10 East Road, N1

proposed south block north elevation

job no. 0761 drawing PA181 rev. A

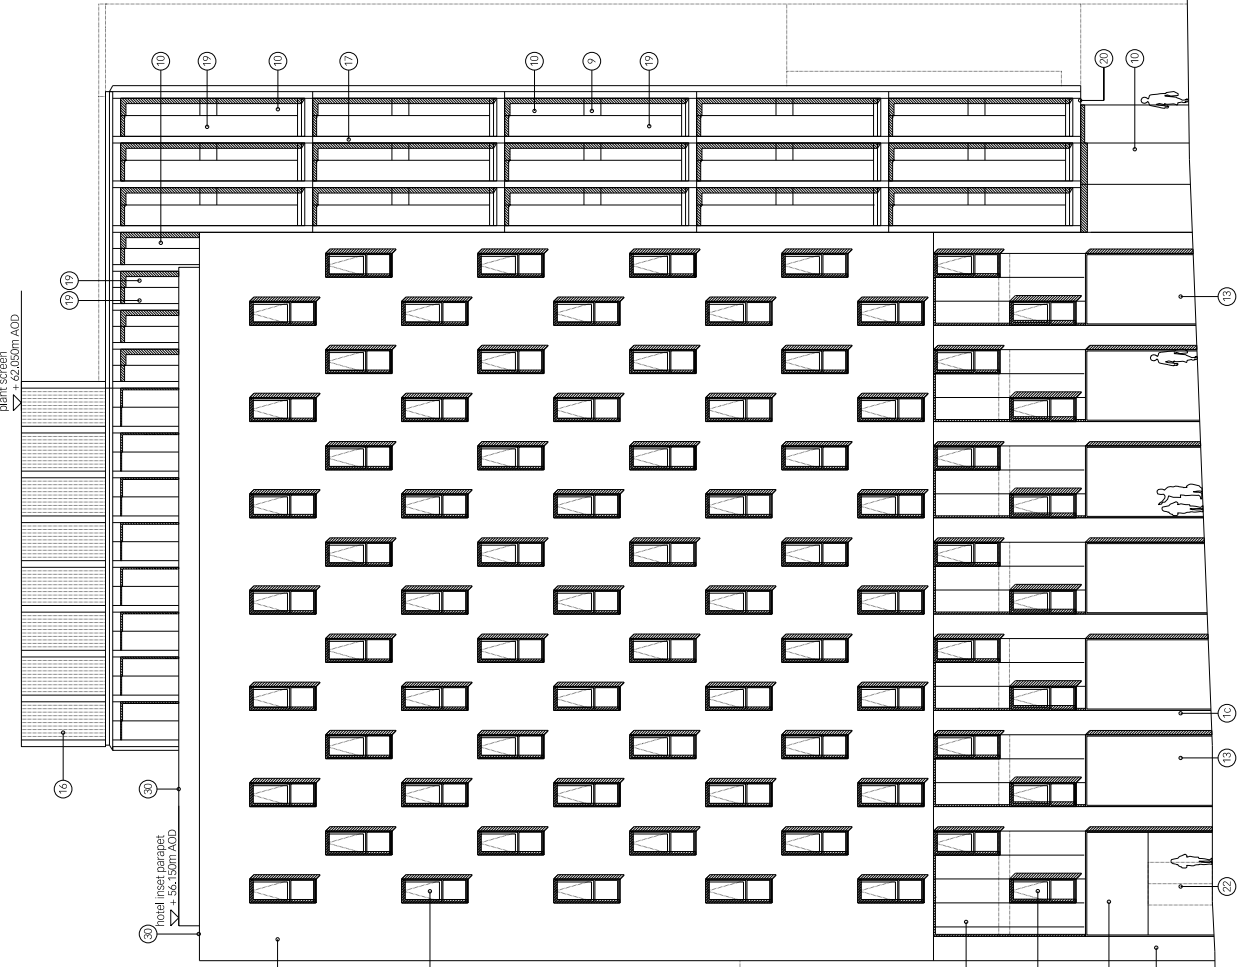
approval of window openings of hotel facade, and revision of facade revised layout of office parapet amended, layout of plant screen and annotations amended.
